VILLAGE OF MORTON GROVE
APPEARANCE COMMISSION

Tuesday, September 2, 2025 - 7:00 P.M.
AGENDA

Re: Appearance Commission Case AC 25-08
Request for an Appearance Certificate for site, building, landscape plans with associated waivers for a 60-unit mixed-use development proposed under Applications for Special Use and Subdivision (PC 25-07) for the property commonly known as 8500-50 Lehigh Avenue (PIN 10-19-204-020-0000, 10-19-203-021-0000, 10-19-203-022-0000, 10-19-203-023-0000, 10-19-203-025-0000, 10-19-203-013-0000) and a portion of Chestnut Street right of way petitioned for vacation (PC 25-08) in Morton Grove, Illinois. The applicant is 8500 MG, LLC.

Proposed Site Plan

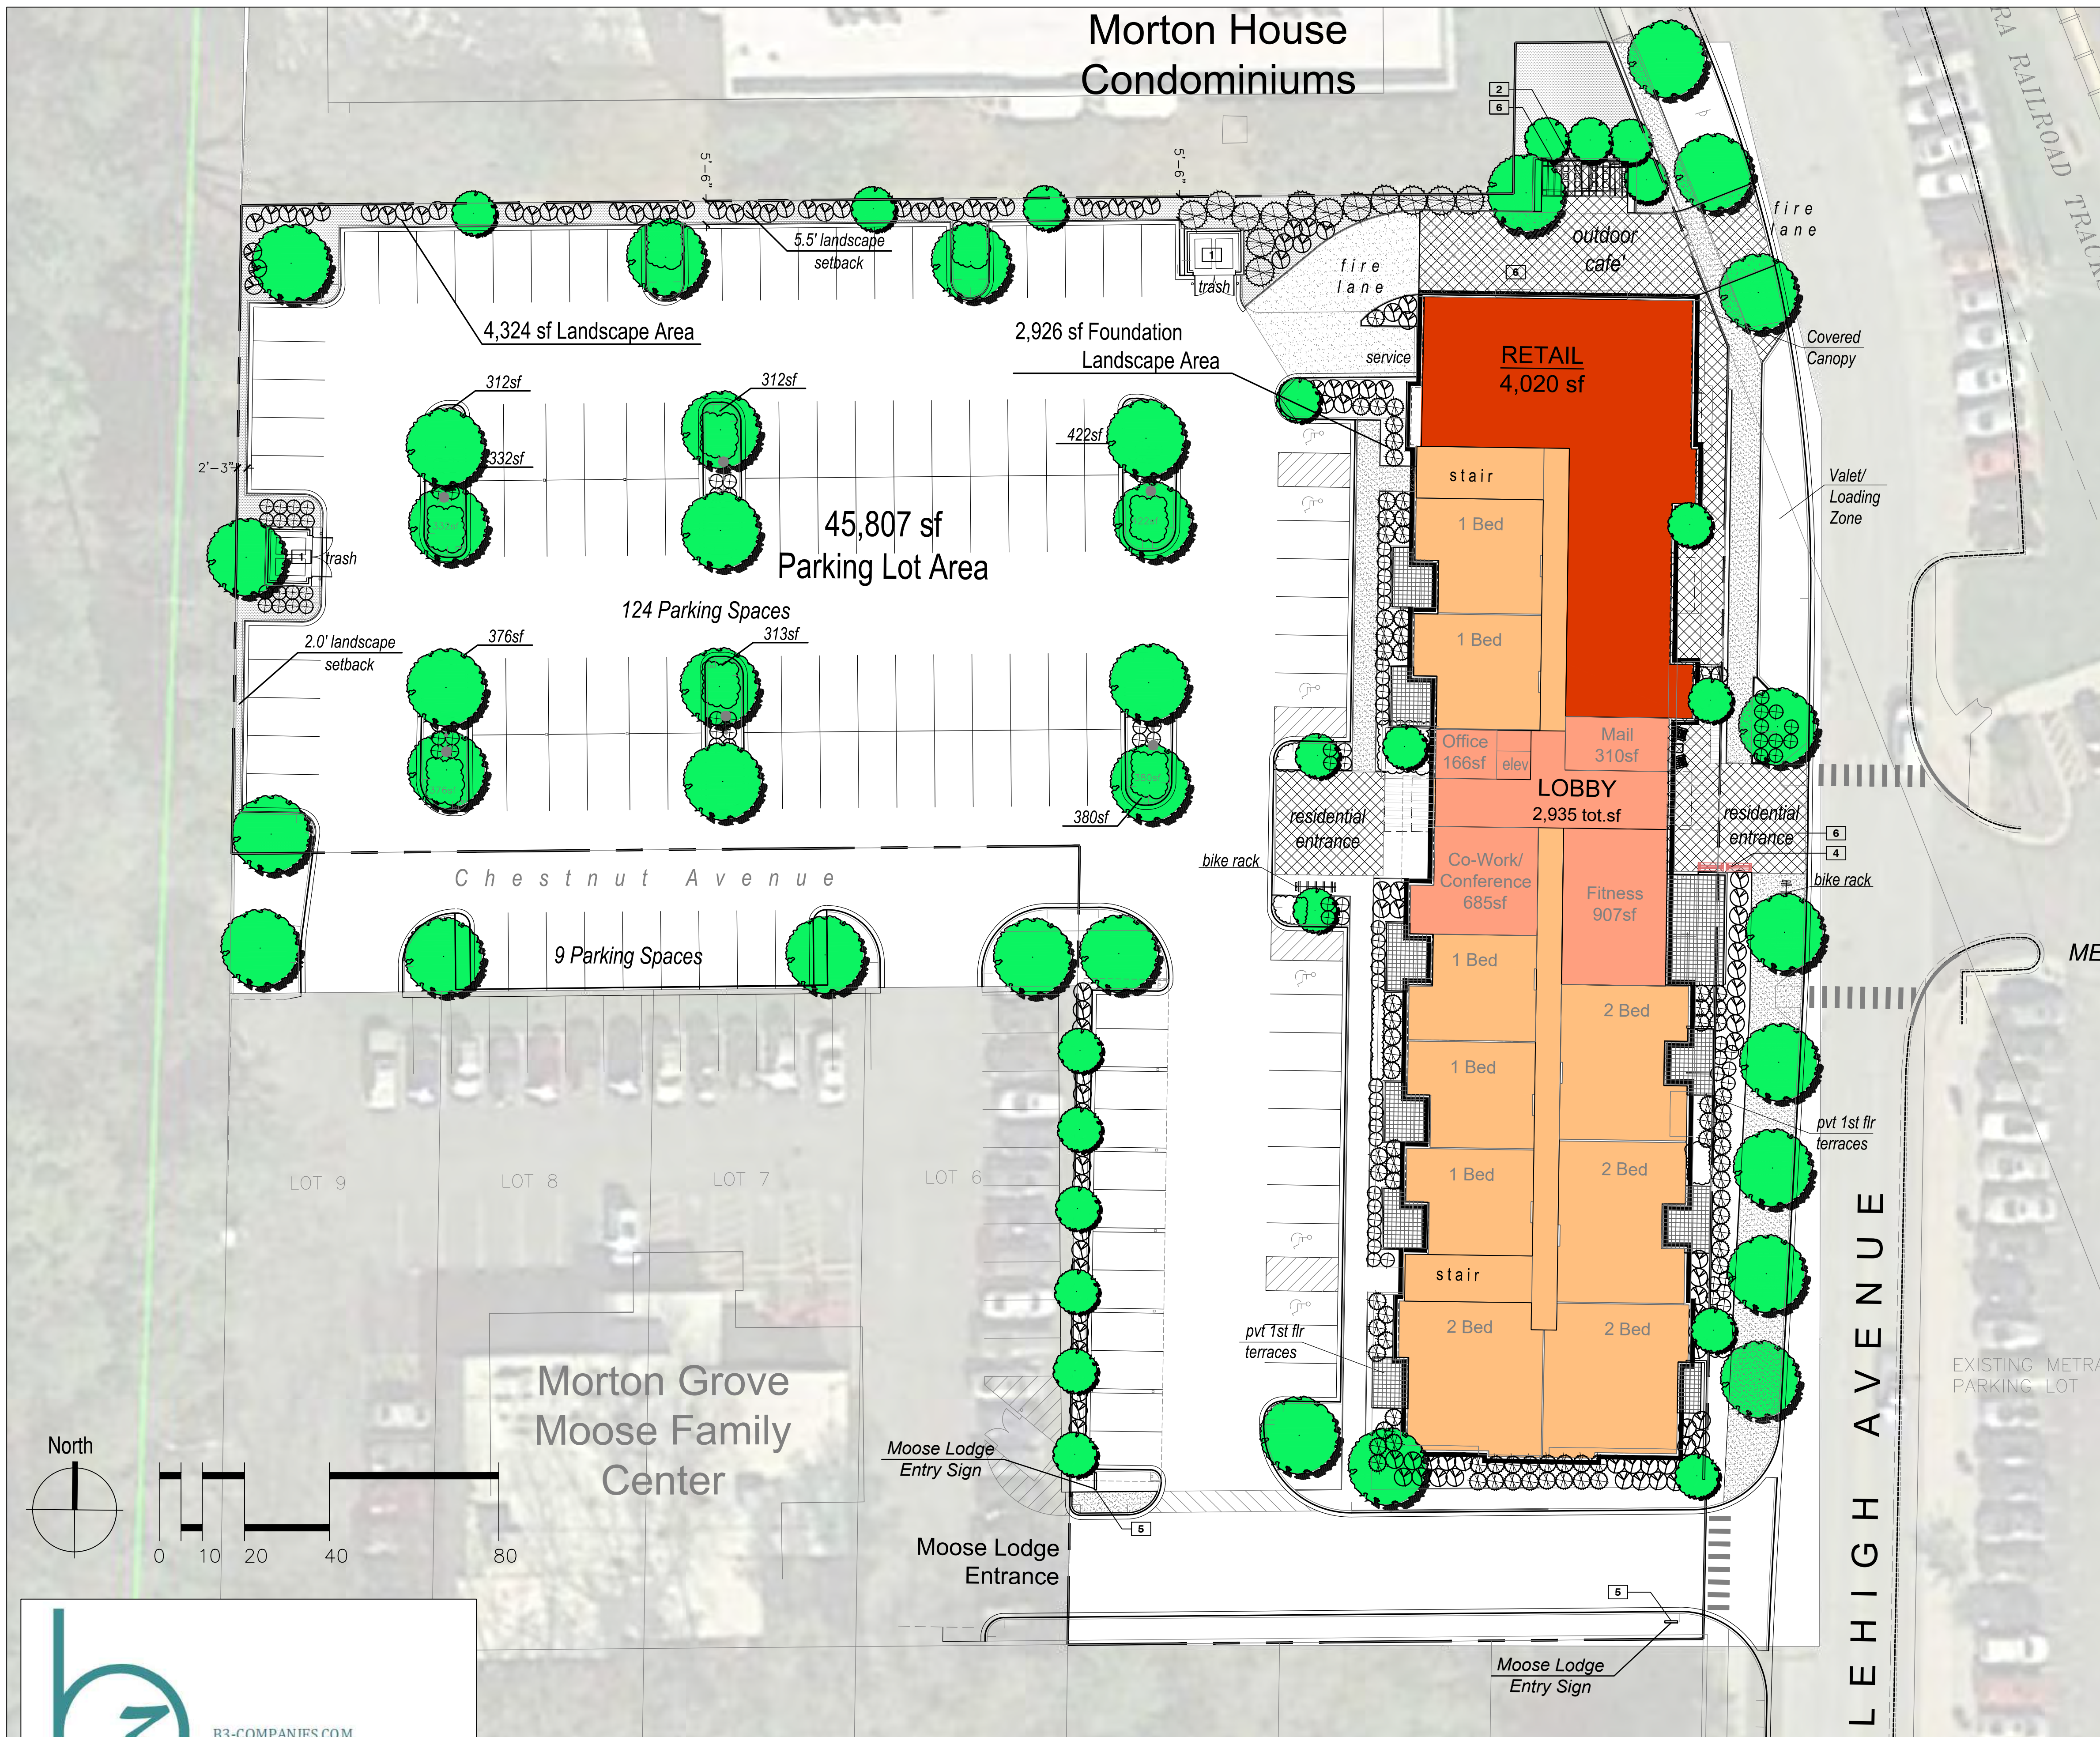
The proposed site plan provides a setback of between 4.1 feet and 5.9 feet at the front lot line along much of Lehigh Avenue creating a strong streetwall. The development's surface parking will be located to the rear of the principal structures and out of view from Lehigh Avenue, so as not to disrupt the pedestrian nature of the streetwall. The use of a singular public vehicular accessway creates a continuity in the streetwall. Recessed balcony areas with small patios on the ground floor and related changes in material break up the façade. A large central building entrance, ground floor residential patios, and a high degree of transparency provided by large ground floor windows will also help provide for a sense of activity at the street level. Landscaping areas along the buildings' frontage and new street trees will also contribute to a vibrant and pedestrian-oriented public realm. The northern side setback will be heavily landscaped to provide buffering between the Morton House Condominiums, an abutting multi-family residential use to the north, and maintain visual interest along Lehigh Avenue.

The site plan and landscape plan and related architectural drawings were revised by the applicant to eliminate a retail space and related outdoor seating area at the south end of the building. Staff has request revised civil drawings that replace the previous, outdated building extent and landscaping.

Conceptual Landscape Plan

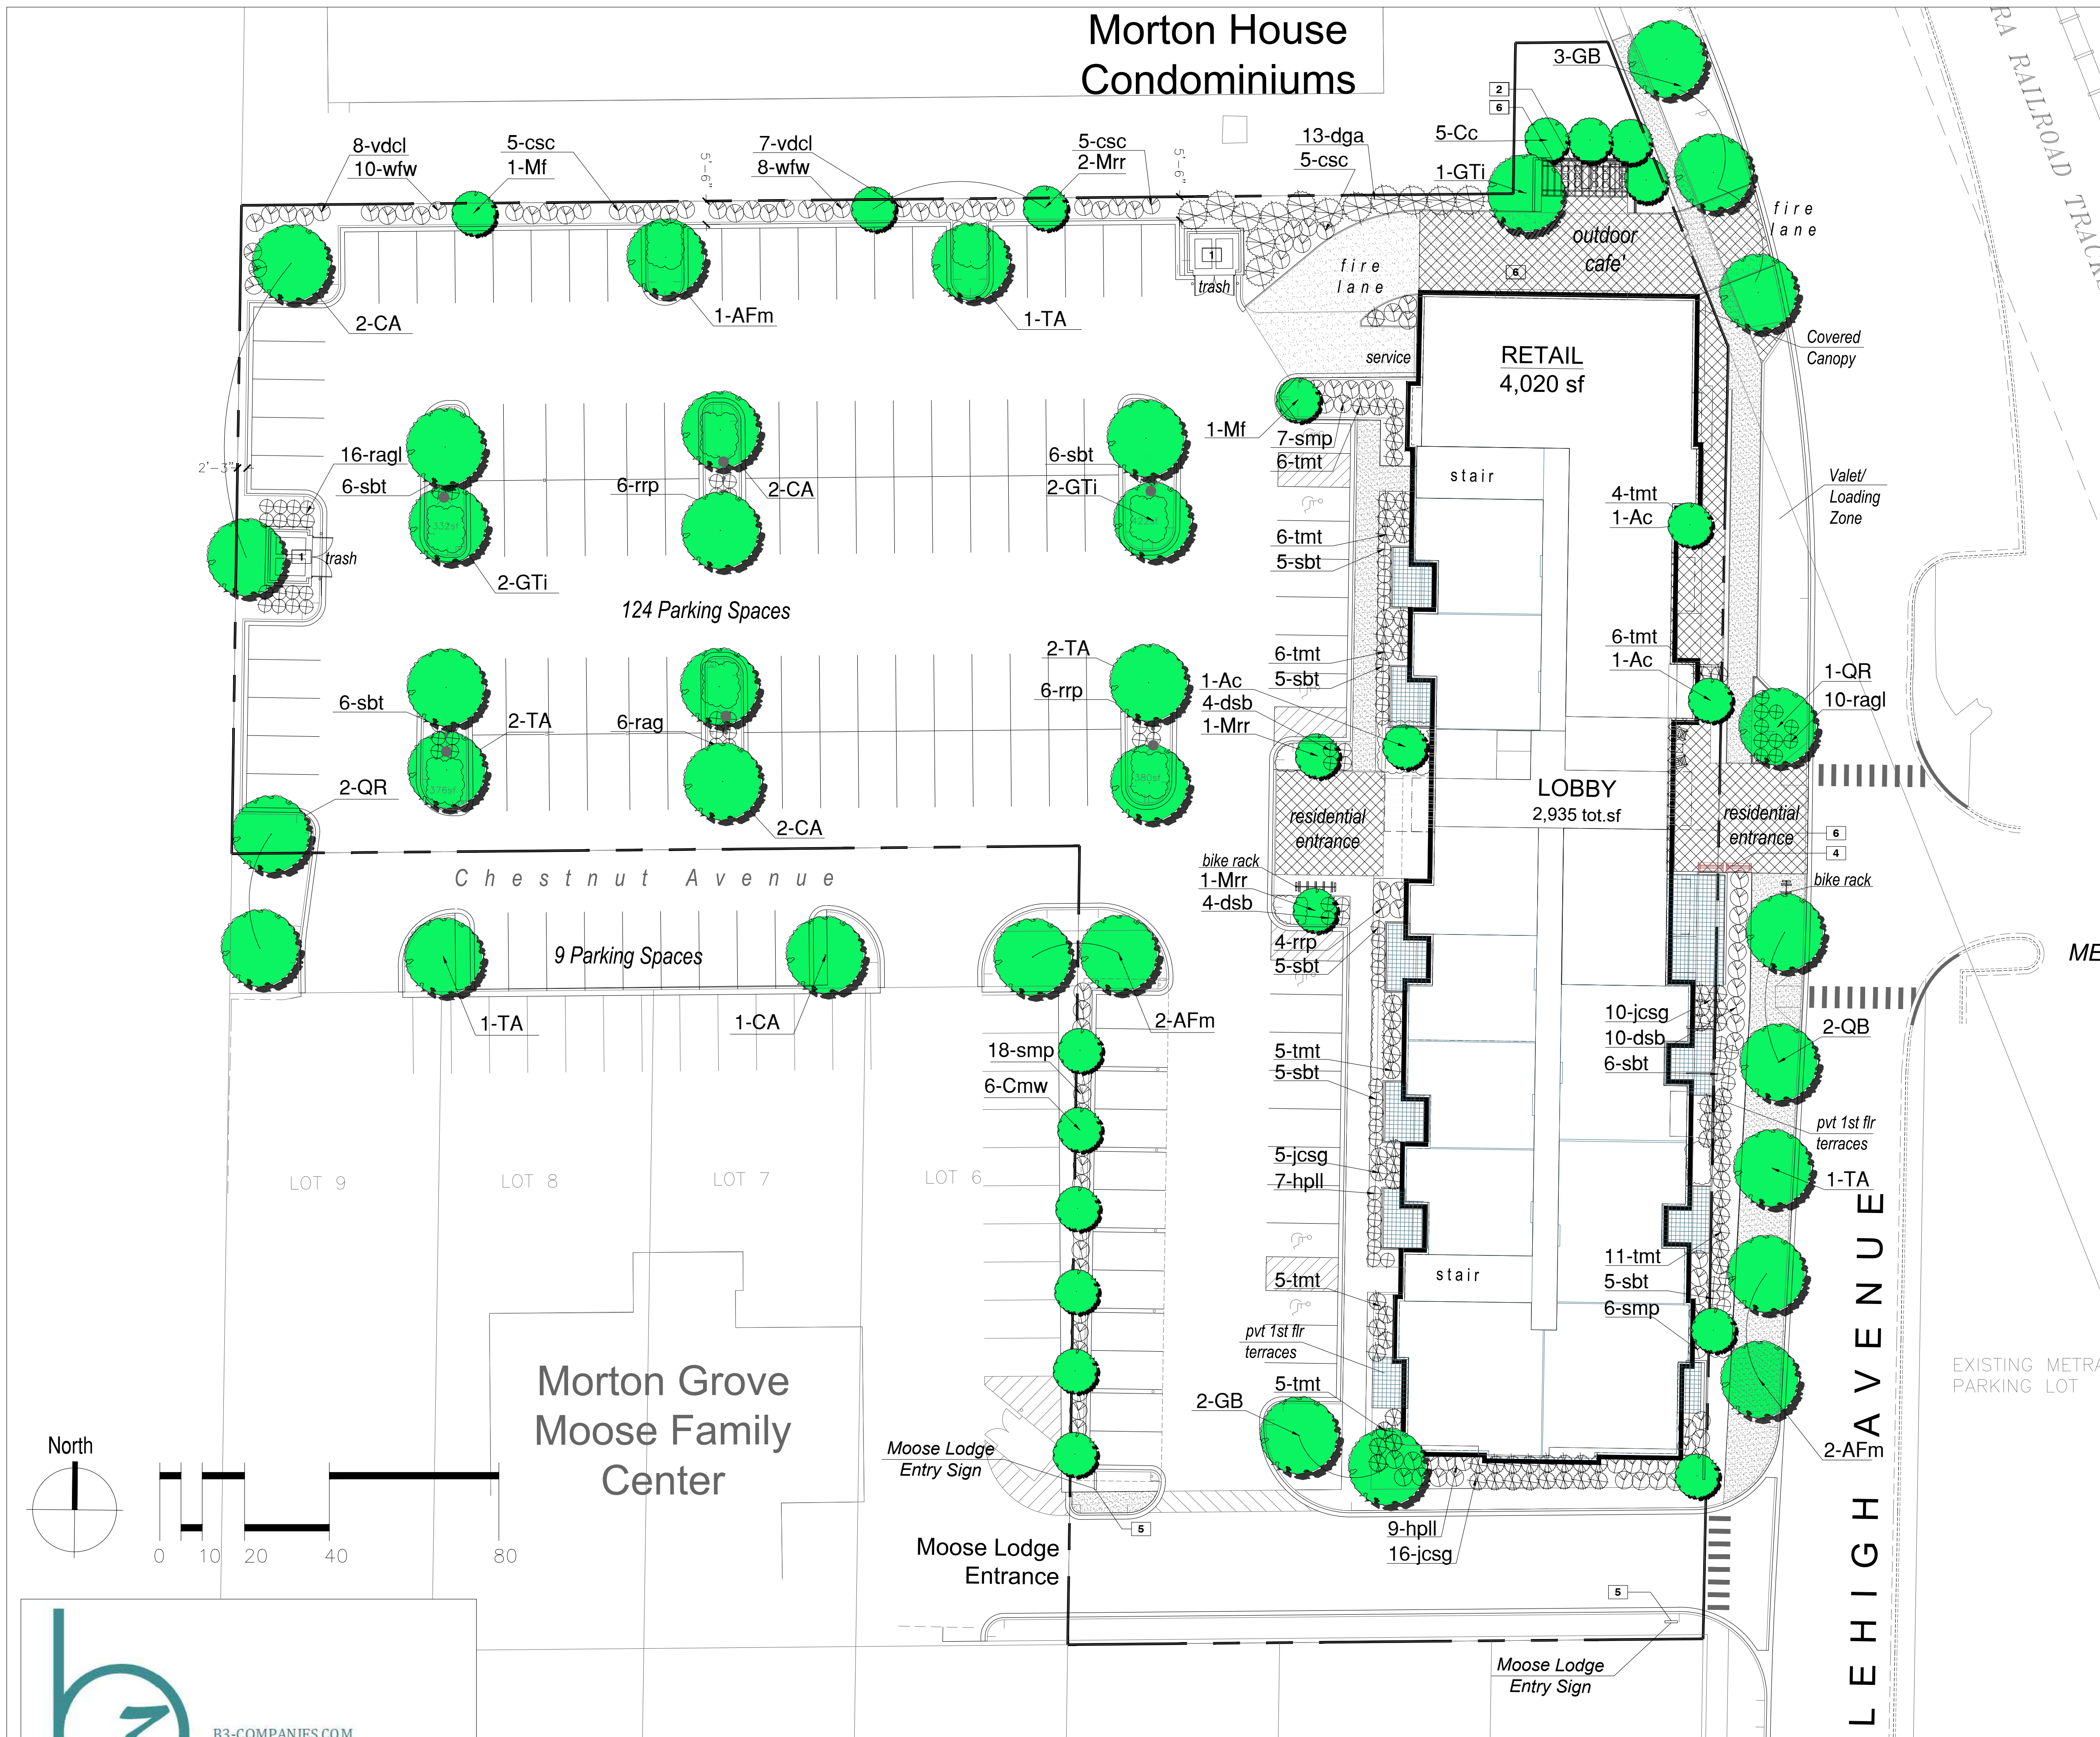
The applicant submitted a landscape plan prepared by RWG, LLC. The applicant is requesting two waivers to the landscaping requirements set forth in Chapter 12-11: (1) a waiver of one tree to the minimum requirement for trees planted in the abutting public right of way and (2) a waiver to permit limited landscaping along the westernmost and southernmost lot lines abutting property owned and operated by the Forest Preserve District of Cook County (FPDCC).

1. *Prior to filing any Building Permit Application, the owner/applicant shall provide the Village with a final landscape plan, including required Tree Protection and Tree Preservation Plans, for review and approval by the Community Development Administrator and Appearance Commission Chairperson. If the landscape plan is deemed to be inconsistent with the approved plan or has not been modified to remove any invasive or undesirable species, the owner/applicant will be required to file an application for an amendment to the Appearance Certificate.*
